# Enhancing physically based and distributed hydrological model calibration through internal state variable constraints

**RC2** (<https://doi.org/10.5194/egusphere-2024-3353-RC2>)

Dear Dr. Modiri,

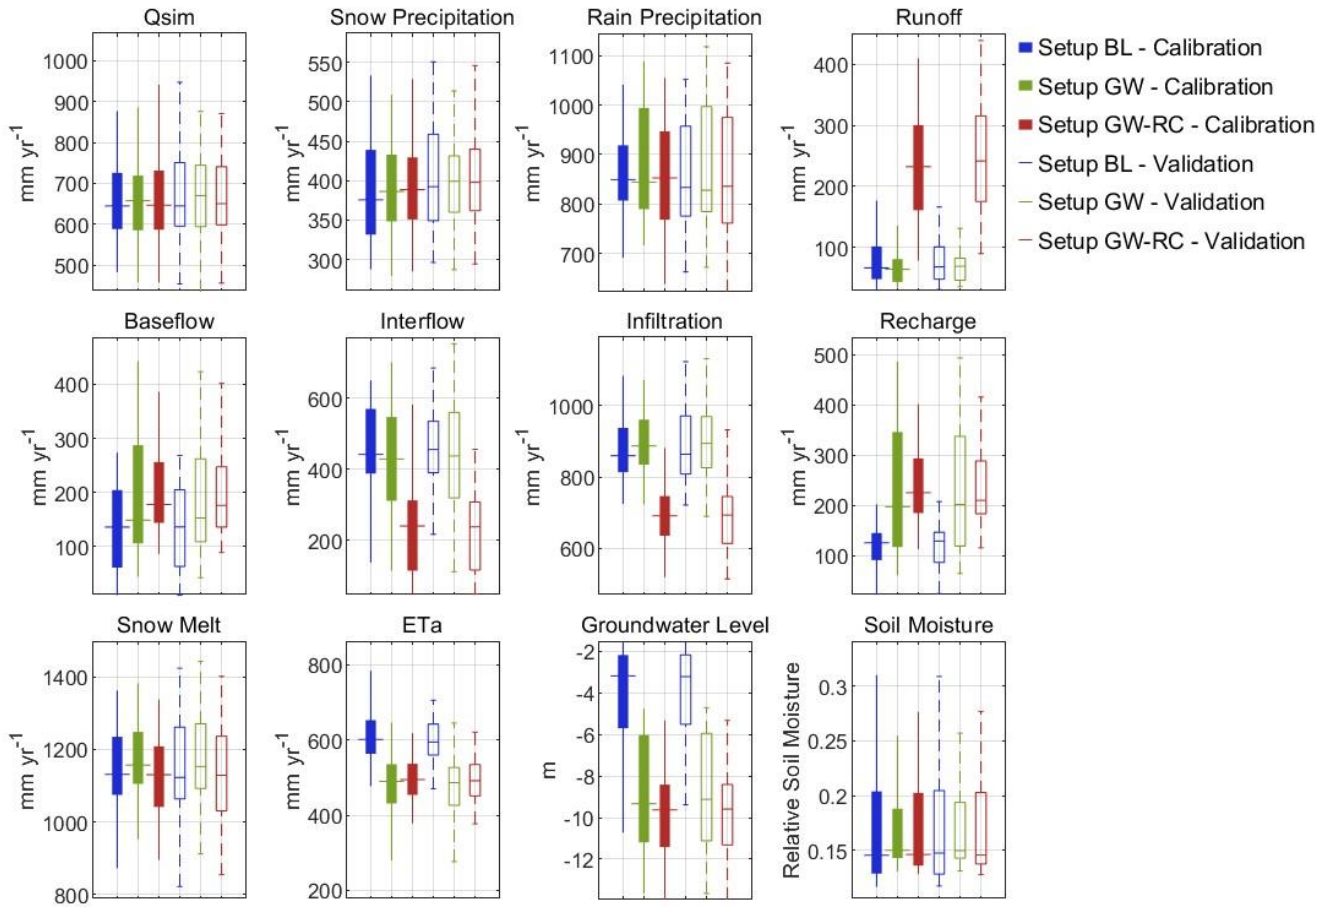
- In Figure3, consider adding each variable’s total mean or sum of observations to enhance the visual comparison. This will allow readers to contextualise the calibration and validation boxplots by providing a reference point for the overall data distribution.

This is a good suggestion. We have modified Figure 3 accordingly. Specifically, we have enhanced the visualization by adding a wider median line for each boxplot and incorporating a grid in each subplot to facilitate comparison between periods and configurations. These adjustments improve readability. Please see the updated figure below.

Figure 5. Boxplots of annual values for key hydrological variables predicted by WaSiM for the 34 catchments and three configurations.

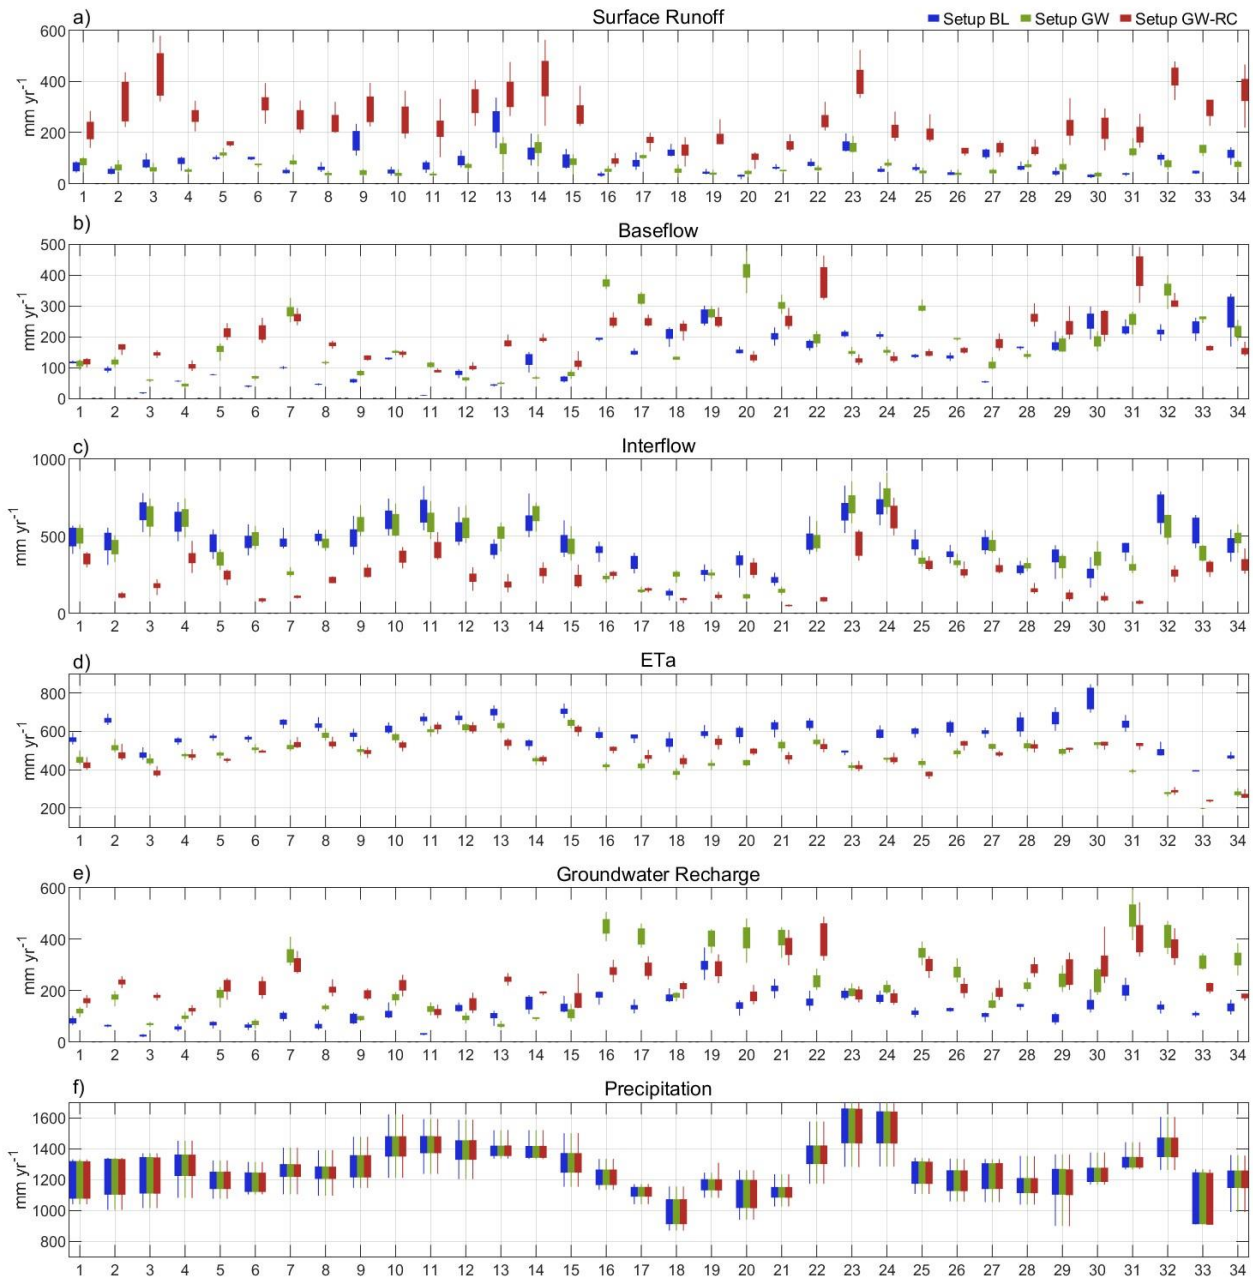
○ Figure 5 reports a difference of around 200 mm/y across all variables among the three configurations for all 34 catchments. To facilitate water balance closure assessment, consider adding a subplot for precipitation data for each basin.

This is a good point. We have modified Figure 5 to include precipitation data in the last subplot to facilitate the assessment of water balance closure. However, since all three configurations use the same precipitation data, the values remain identical across configurations. A revised version of Figure 5 is provided below.
